UNITED STATES PATENT AND TRADEMARK OFFICE

APPLICATION NO.	FILING DATE	FIRST NAMED INVENTOR	ATTORNEY DOCKET NO.	CONFIRMATION NO.
10/631,041	07/29/2003	Jean-Claude Villeneuve	TJK/403	9274
27717	7590	02/02/2006		
SEYFARTH SHAW LLP 55 E. MONROE STREET SUITE 4200 CHICAGO, IL 60603-5803			EXAMINER CAZAN, LIVIUS RADU	
			ART UNIT	PAPER NUMBER
			3729

Office Action Summary

DETAILED ACTION

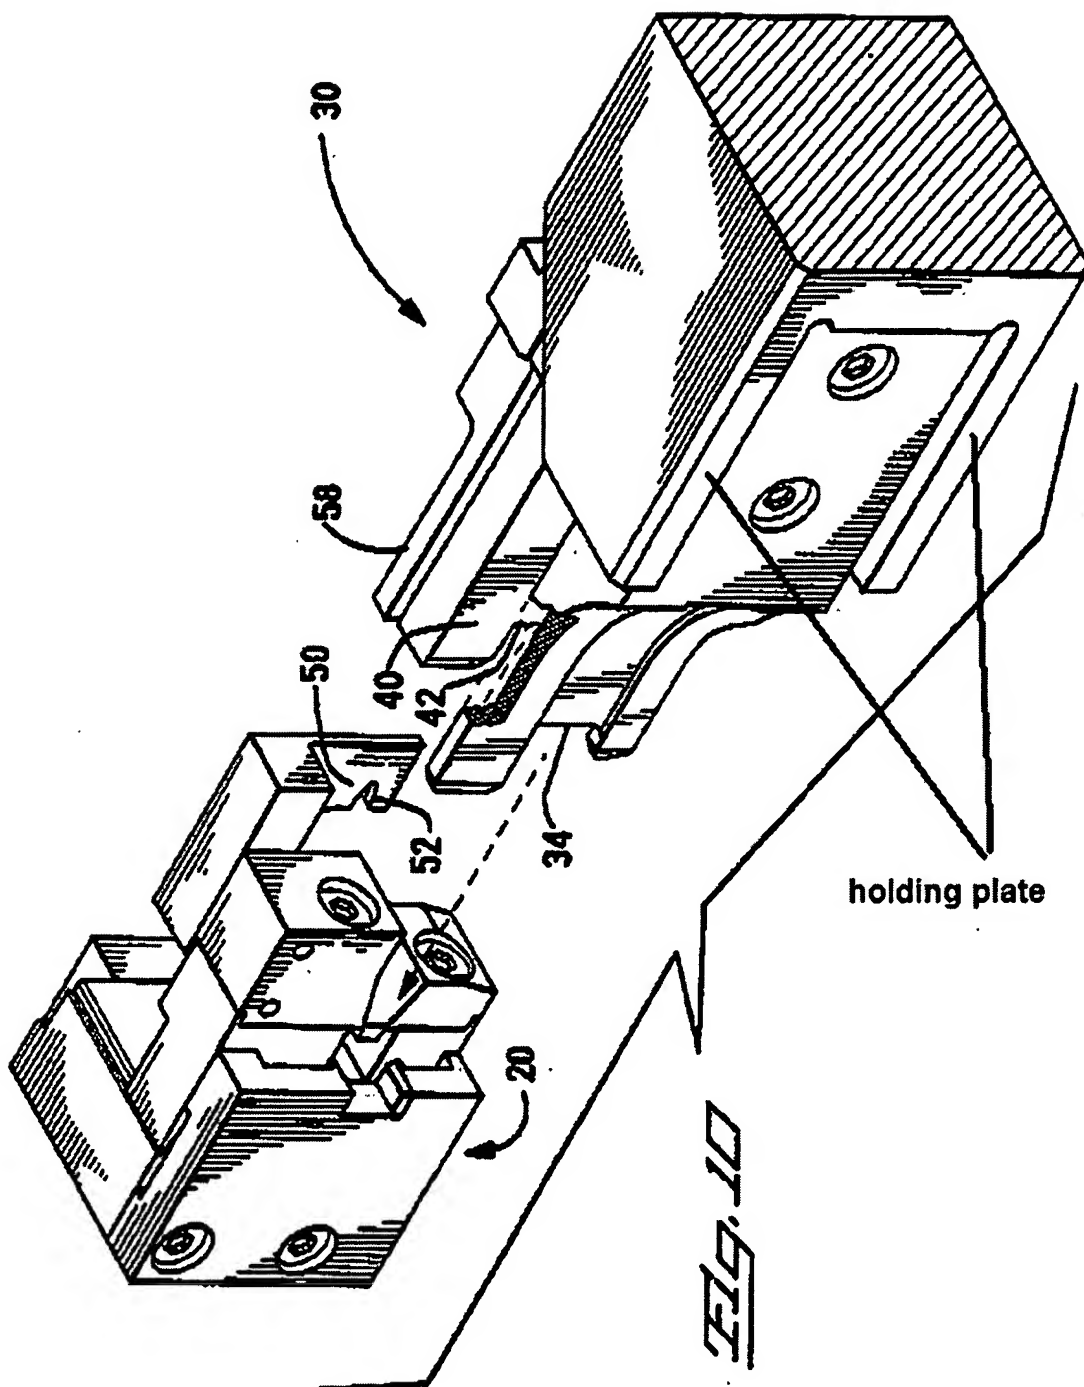
15. Claim 17 is rejected under 35 U.S.C. 103(a) as being unpatentable over Matsui in view of Orphanos et al. (US5357669)

Matsui discloses the same invention as the applicant, including a wire cutter tool operatively connected to a second actuator.

Matsui does not disclose a wire cutter tool mounted inside a holding plate.

Orphanos et al. teach a crimping apparatus which employs a cutter tool that is slidably mounted in a holding plate (see image below; also Fig. 10 in Orphanos et al.)

Therefore it would have been obvious to one of ordinary skill in the art at the time the invention was made to modify the wire cutter of Matsui, in view of the teachings of Orphanos et al., by employing a cutter which is slidably mounted in a plate, in order to facilitate quick removal and replacement with a different cutter.
